# UNITED STATES PATENT AND TRADEMARK OFFICE

10/518,712

Marco Biasiotto

## DETAILED ACTION

**Takahashi '4,895,000 Figure 1 Prior Art**

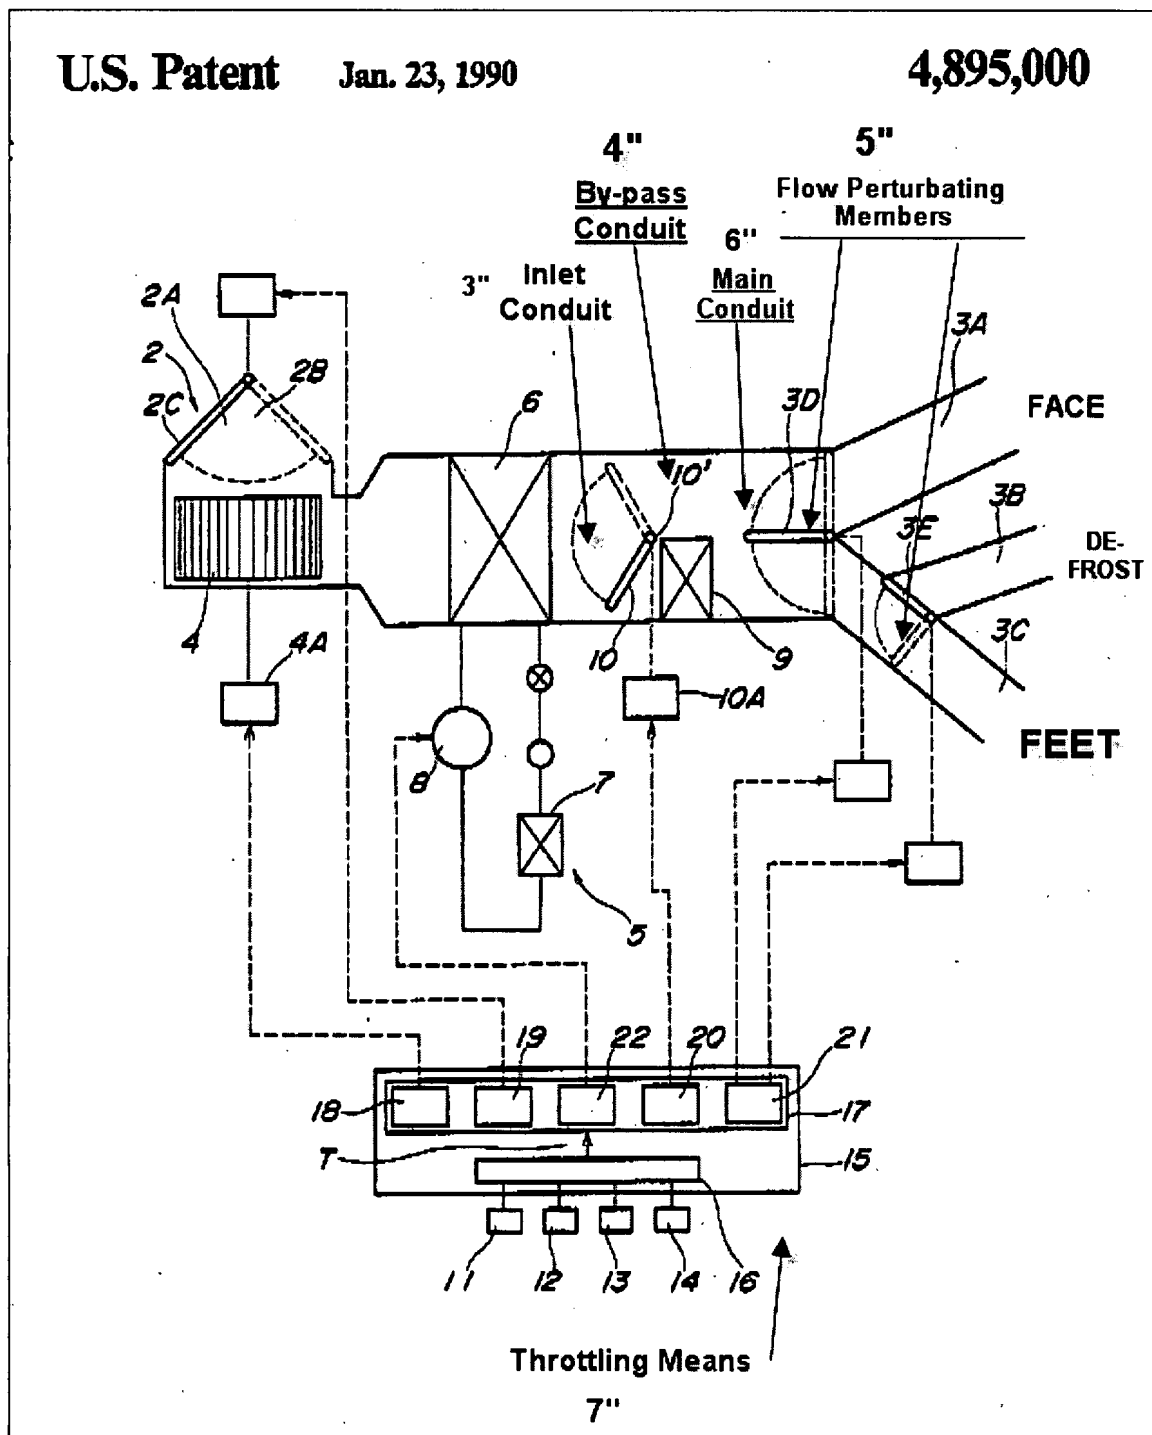
14. In re claim 1, Takahashi '000 discloses an air distributor device (figure 1) including: a structure defining a main conduit (6") and a plurality of outlet conduits (3A, 3B, 3C) communicating with the main conduit (6") and to be connected to a plurality of outlets for the outflow of air into the motor vehicle passenger compartment, Coanda effect distributor means mounted in the structure of the distributor device and movable to a plurality of operative positions each causing deviation, by the Coanda effect, of the air flowing through the main conduit (6") into a selected one of said outlet conduits (3A, 3B,

3C), characterized in that said distributor device further comprises: a radiating mass (9) positioned upstream of the main conduit (6") in such a way as to be traversed by the flow of air which arrives into the main conduit (6") from an inlet conduit (3") of the distributor device, to heat said flow of air, means which determine a variation of the temperature of the flow of air conveyed in said main conduit (6"), said means being controlled by said Coanda effect distributor means, in such a way that the temperature of the air flowing out of the distributor device is a function of the operative position (i.e. air-mixing damper (10)) of said Coanda effect distributor means. (See note 1 below)

**Note 1**

**Coanda effect distributor means** in prior art is simply identified as air-conditioning unit with the **Coanda Effect** taking place within it inherently as air flows along its smooth walls. Dampers have ability to 'throw' air to opposite wall of hinged side where air continues its "gripping" flow.

15. In re claim 2, Takahashi '000 discloses said distributor device (figure 1) further comprises a by-pass conduit (4") which connects the inlet conduit (3") to the main conduit (6") in parallel to the portion of conduit where the aforesaid radiating mass (9) is positioned, and means for throttling (7") obstructing the various distributor flow of the said by-pass said by-pass operative positions of the Coanda effect means which determine the deviation of the main conduit (6") into one of the aforesaid conduit (3A, 3B, 3C) for variably conduit depending upon outlet conduits (3A, 3B, 3C), in such a way that the temperature of the flow of air exiting the distributor device has different values depending on which outlet conduit (3A, 3B, 3C) has been selected through said Coanda effect distributor means . (See note 1 above)

**4,895,000**

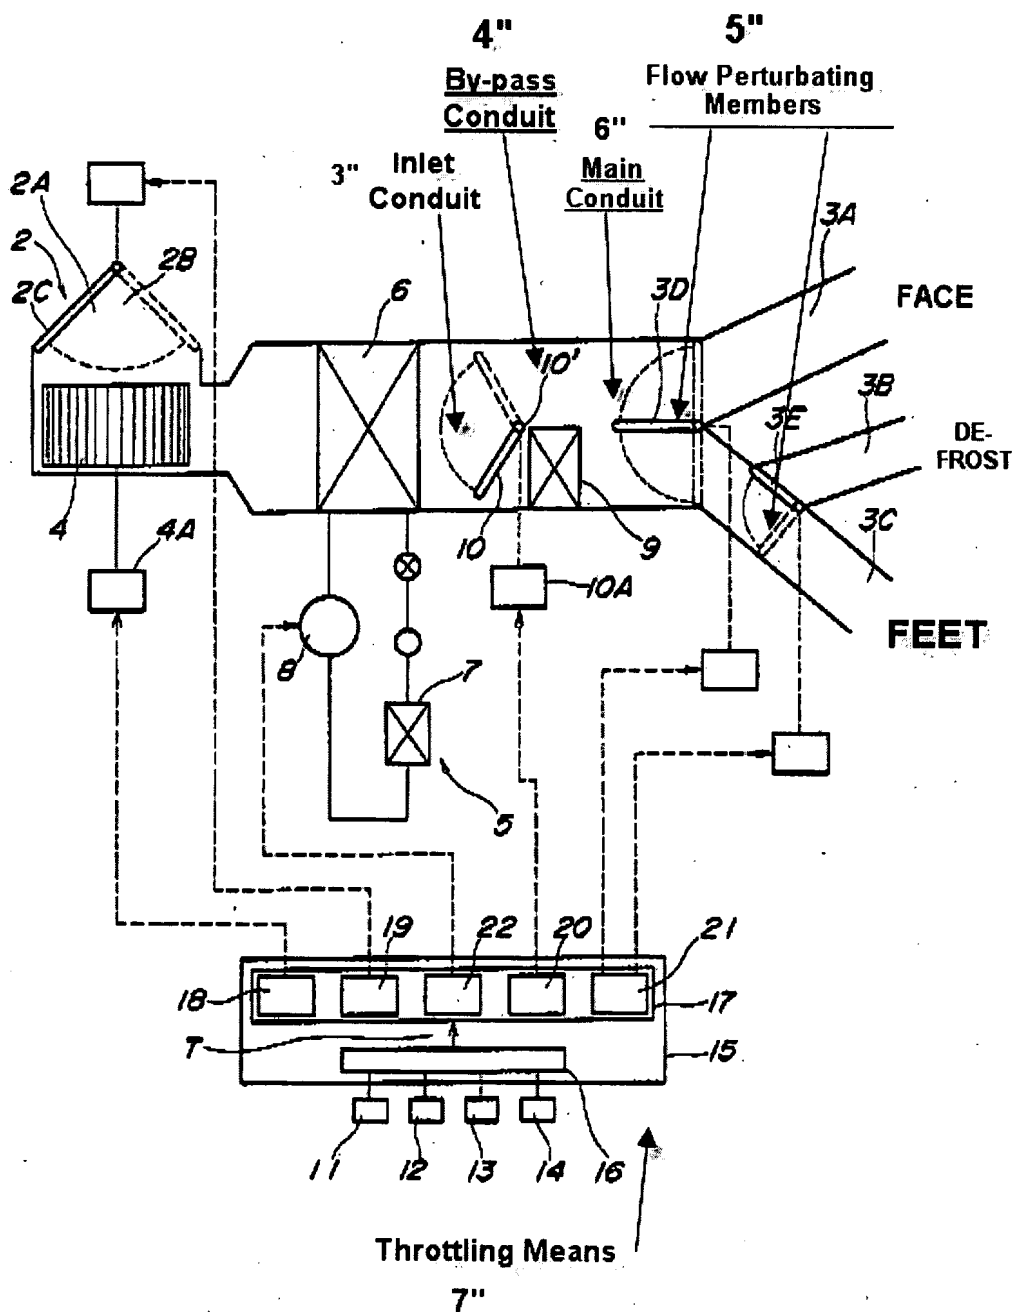
16. In re claim 3, Takahashi '000 discloses invention above, and further discloses said Coanda effect distributor means comprise at least a flow perturbing member (5") having at least two different operative positions to cause the deviation, by Coanda effect, of the flow of air that travels through the main conduit (6") at least into a first (3A)

or into a second (3B, 3C) outlet conduit, and in that said throttling means (7") are constituted by a shutter (10) mechanically connected to said flow perturbing member (5"). (See note 1 above)

17. In re claim 8, Takahashi '000 discloses the distributor device further comprises a mixing controlling shutter (10) which controls an opening which places the inlet conduit (3") in communication directly with the main conduit (6"), in parallel with respect to the conduit portion in which the radiating mass (9) is positioned.

18. In re claim 10, Takahashi '000 discloses invention above and further discloses three outlet conduits (3A, 3B, 3C) respectively to be connected to outlets which direct the air adjacent to the floor of the motor vehicle passenger compartment, to outlets situated in the front part of the dashboard of the motor vehicle oriented towards the occupants of the motor vehicle, and to outlets situated at the base of the windshield of the motor vehicle, and in that the aforesaid throttling means (7") are shaped and positioned in such a way as to generate in the main conduit (6") a flow having a first, relatively lower, temperature, when the Coanda effect distributor means deviate the flow of air into the outlet conduit (3A) communicating with the front outlets (FACE), a flow of air at a second, relatively higher temperature when the Coanda effect distributor means send the flow of air from the main conduit (6") to the outlet conduit (3C) connected to the outlets adjacent to the floor of the motor vehicle (FEET) passenger compartment, and a flow of air having a third, still higher temperature, when the Coanda effect distributor means deviate the flow of air from the main conduit (3) to the third outlet conduit (3B) communicating with the outlets situated at the base of the windshield of the motor vehicle (DEFROST). See note 2 below.

Heating core (3) is disposed directly in front of conduit which feeds front outlets (FACE) and windshield (DEFROST) outlets and with the proper opening angles of dampers (shutters) claim limitation regarding varying temperature across the three outlets (3A,

3B, 3C) can be achieved, especially being that the warmest temperatures are from the face and windshield outlets.

19. In re claim 11, Takahashi '000 discloses invention above and further discloses it is provided with means for regulating the heating or cooling air including a mixing controlling shutter (10) which controls an opening that places the inlet conduit (3") of the distributor device directly in communication with the main conduit (6") in parallel to the portion of conduit in which the radiating mass (9) is positioned, characterised in that said mixing controlling shutter (10) is operatively connected to said Coanda effect distributor means, in such a way that to different operative positions of the Coanda effect distributors also correspond different operative positions of the mixing controlling shutter (10). See notes 1 and 2 above.

**Kawai et al '6,138,749 Figure 2**

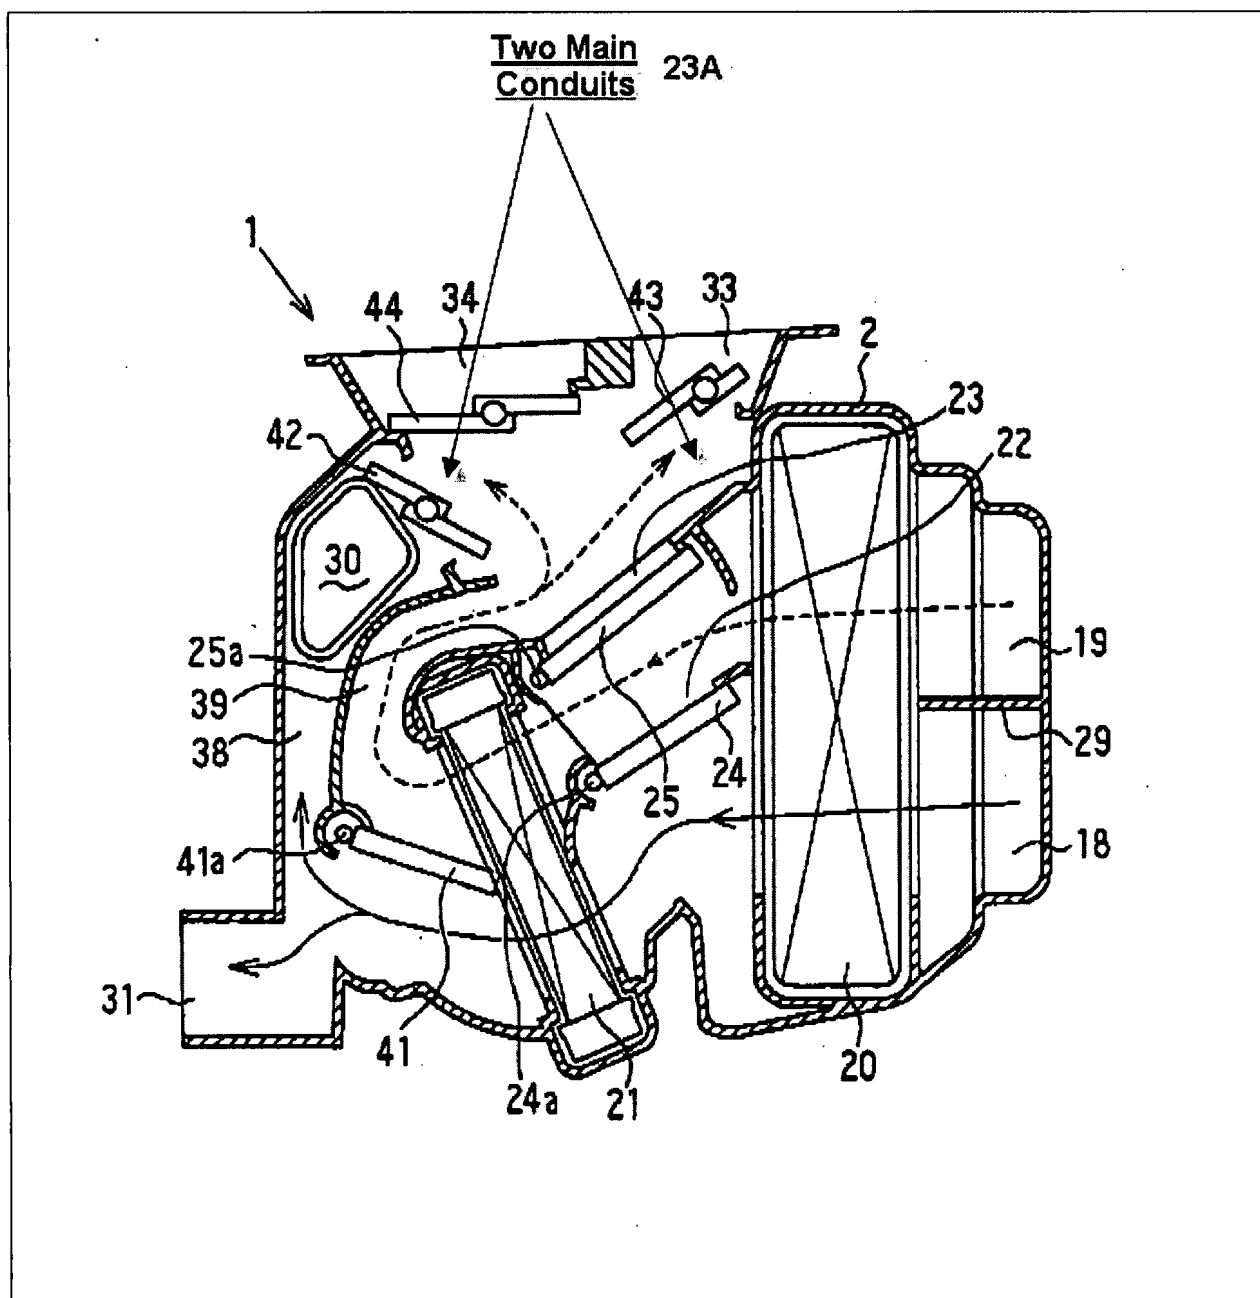
21. In re claim 1, Kawai et al '6,138,749 discloses an air distributor device (figure 2) including: a structure defining a main conduit (23A) and a plurality of outlet conduits (30, 33, 34) communicating with the main conduit (23A) and to be connected to a plurality of outlets for the outflow of air into the motor vehicle passenger compartment, Coanda effect distributor means mounted in the structure of the distributor device and movable to a plurality of operative positions each causing deviation, by the Coanda effect, of the

air flowing through the main conduit (23A) into a selected one of said outlet conduits (30, 33, 34), characterized in that said distributor device further comprises: a radiating mass (21) positioned upstream of the main conduit (23A) in such a way as to be traversed by the flow of air which arrives into the main conduit (23A) from an inlet conduit (18, 19) of the distributor device, to heat said flow of air, means which determine a variation of the temperature of the flow of air conveyed in said main conduit (23A), said means being controlled by said Coanda effect distributor means, in such a way that the temperature of the air flowing out of the distributor device is a function of the operative position (i.e. air-mixing damper (24, 25)) of said Coanda effect distributor means. (See note 1 above)

24. In re claim 9, Kawai et al '749 discloses invention above and further discloses an air distributor and mixer assembly comprising a plurality of main conduits (23A) set

mutually side by side and each communicating with a plurality of outlet conduits (30, 33, 34), each main conduit (23A) being provided with respective Coanda effect distributor means, with a respective by-pass conduit (22, 23) and with respective throttling means (24, 25). As best understood applicant is claiming two or more air distribution devices in unison. Kawai et al '749 does contain some redundancies reading into claim language, however does not claim to be a plurality of devices. Furthermore, patentable weight for the duplication of parts is not granted per MPEP citation below. Submission of amended drawing set and concise description of embodiment in specification will resolve all issues regarding claim structure.

**Kawai et al '6,138,749 Figure 5**

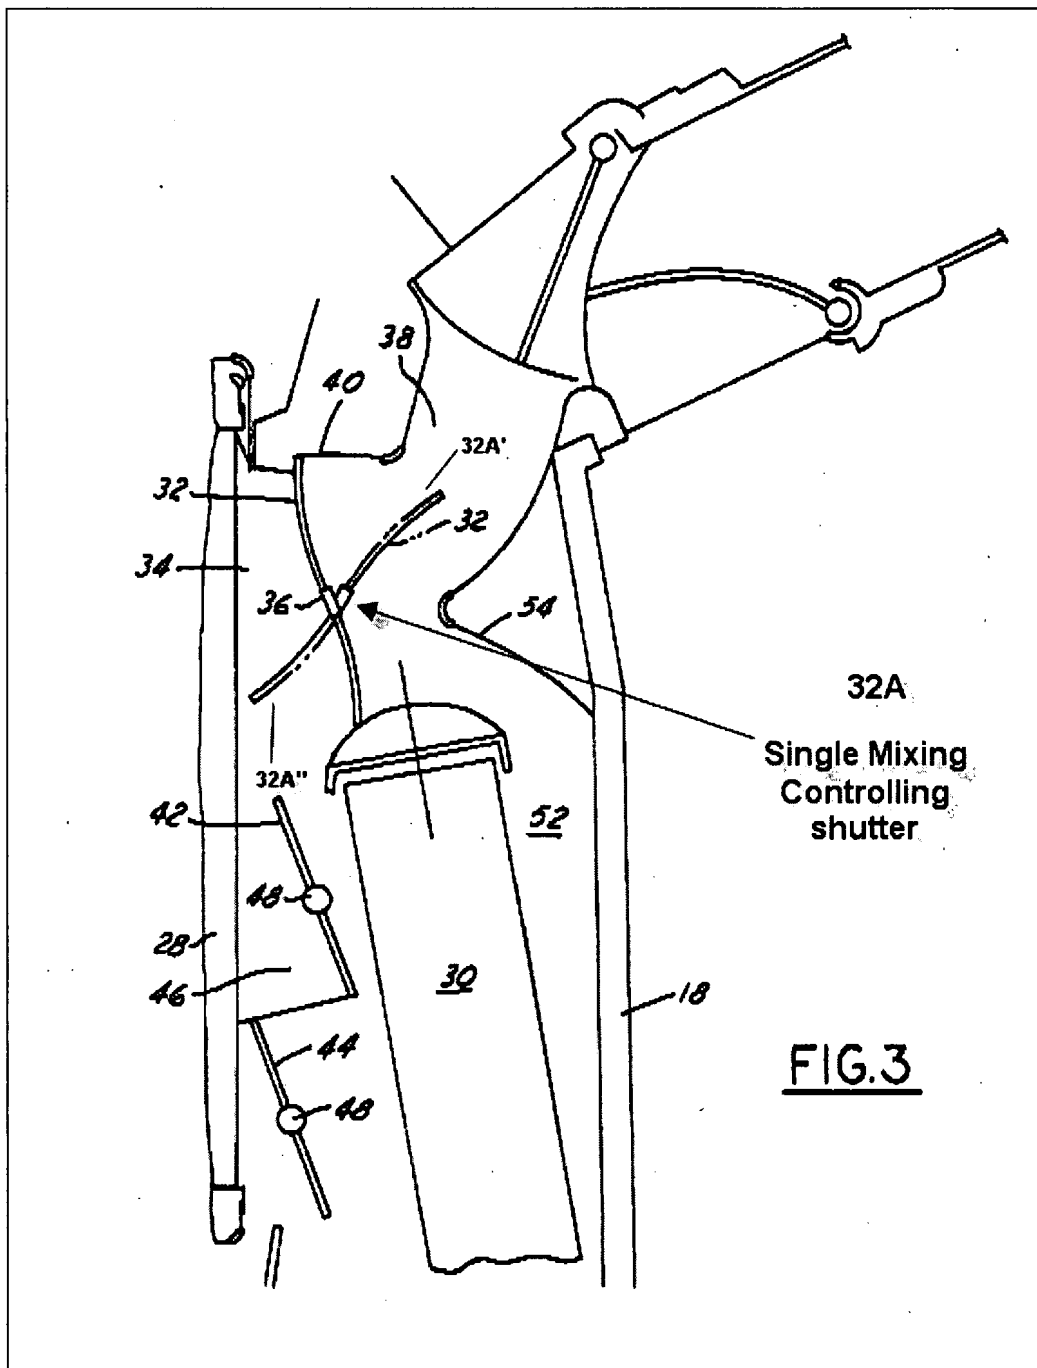
26. In re claim 13, Kawai et al '749 discloses invention above and further discloses at least two main conduits (23A) set mutually side by side, communicating with respective sets of outlet conduits (30, 33, 34, figure 2) which in turn are connected to a series of outlets situated in the central (32, 35, 36, figure 5) part of the dashboard of the motor vehicle and to a series of outlets situated on a side (37, figure 5) of the dashboard of the motor vehicle.

27. However, Kawai et al '749 fails to disclose that to the two aforesaid main conduits is associated a single mixing controlling shutter comprising two portions, angularly offset from each other and positioned in a single chamber for feeding air to the two main conduits, in such a way as to favor a greater flow of cold air towards the main conduit communicating with the central outlets than towards the main conduit communicating with the lateral outlets.

Kwon et al '6,036,594.' Figure 3

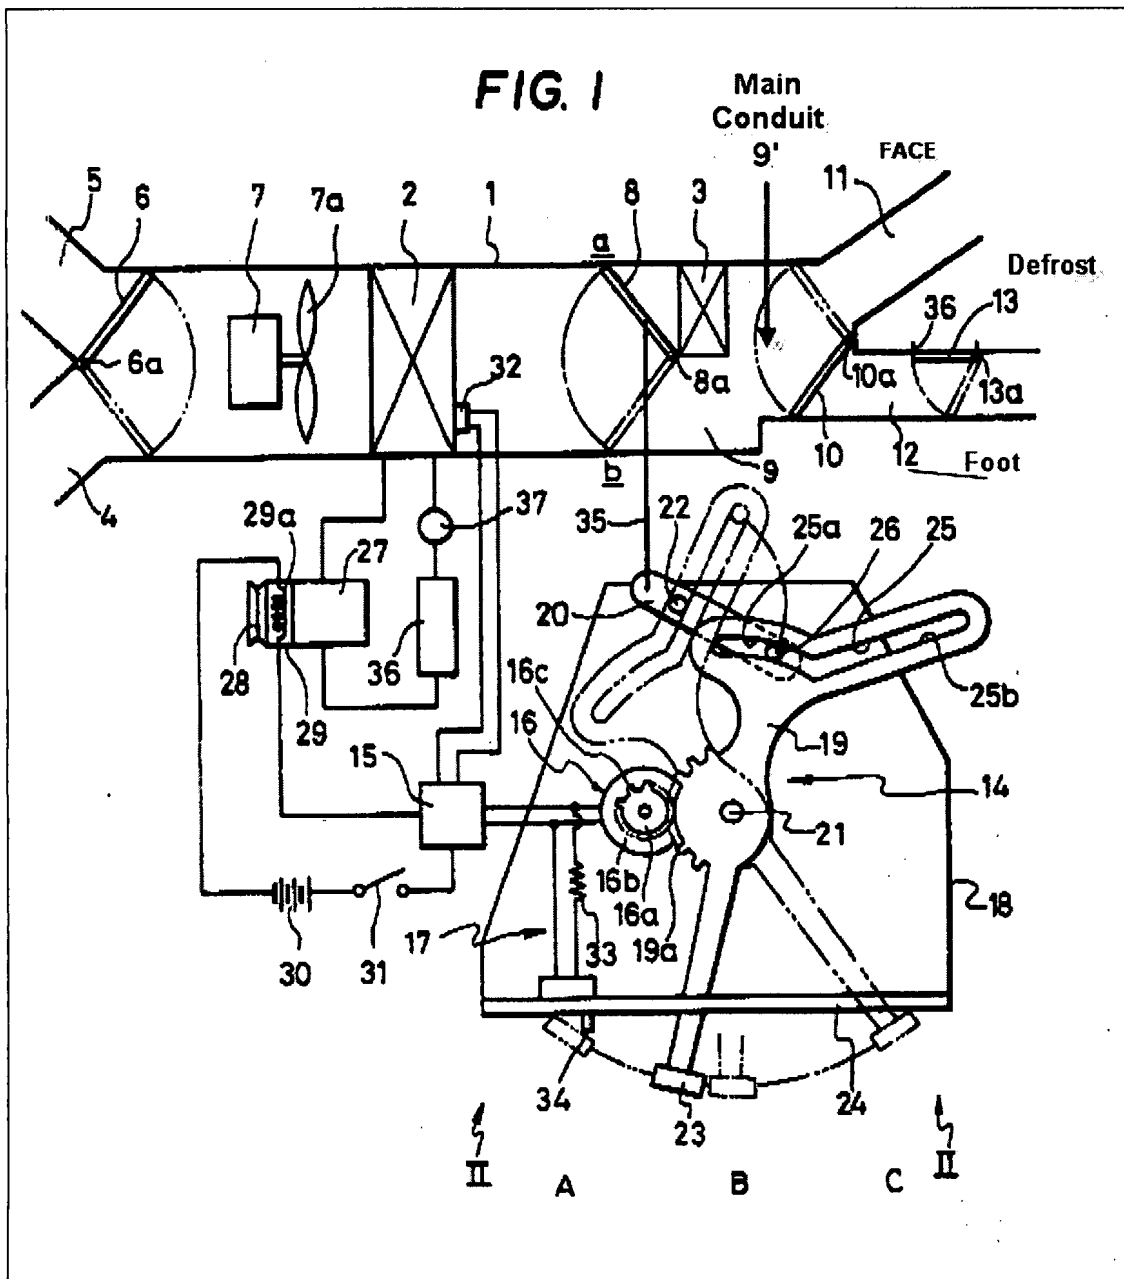
28. Nevertheless, Kwon et al '594 discloses that to the two aforesaid main conduits is associated a single mixing controlling shutter (32A) comprising two portions (32A', 32A''), angularly offset (see figure 3 above) from each other and positioned in a single chamber for feeding air to the two main conduits, in such a way as to favor a greater flow of cold air towards the main conduit communicating with the central outlets (Kawai et al '749, FIG. 5, 32, 35, 36, ) than towards the main conduit communicating with the lateral outlets (Kawai et al '749 , FIG. 5, 37).

29. It would have been obvious to one of ordinary skill in the art at the time of the invention was made to modify Kawai et al '749 with Kwon et al '594 in teaching the incorporation of a single mixing controlling shutter with two portions angularly offset to help "bend" air flow in a direct fashion toward desired outlet.
